S E R V I C E N O T E

71612A 12 Gb/s HSBER System**70843 Serial Numbers:** 3331U00135 / 3501U00163

This service note describes modifications to two of the 71612A 12 Gb/s HSBER system components. The units affected are the 70004A and the 70843A.

Single Piece Cover

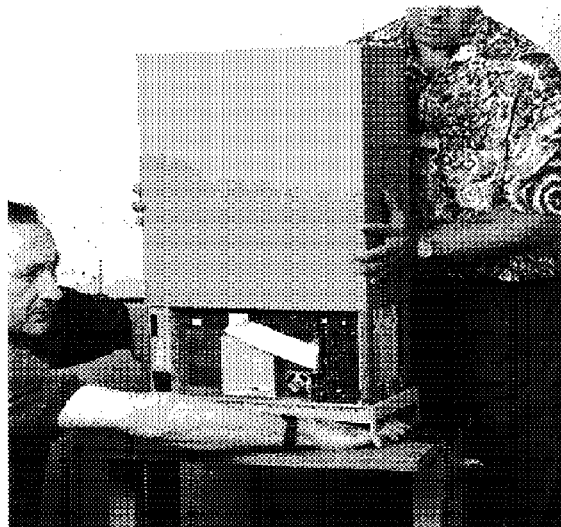
- Install the 70843A front handles (if they are not already installed).
- Remove the 15 screws around the rear of the cover and the 4 rear feet.
- Remove the 3 rear panel fixing screws and remove the rear panel.
- Remove the bottom feet and store the information card and tray in a safe place.

The cover can now be removed as shown in Figure 1. One person should hold down the handles while another person pulls on the sides of the cabinet cover from the rear of the unit.

Take care not to trap any cables while removing the cover.
